# Access Compliance Report

## Public Rights-of-Way

### (Pedestrian Signals)

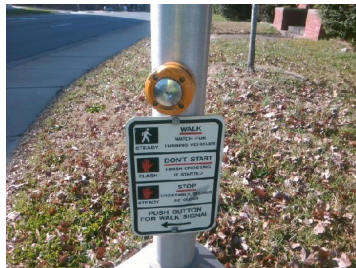
PROW/ADA: TMUTCD 4e.08, R404.3, R406.2, R404.7.3

Possible Solutions: Replace Signal Push Button With APS Button on New Post. Remove & Relocate Sign.
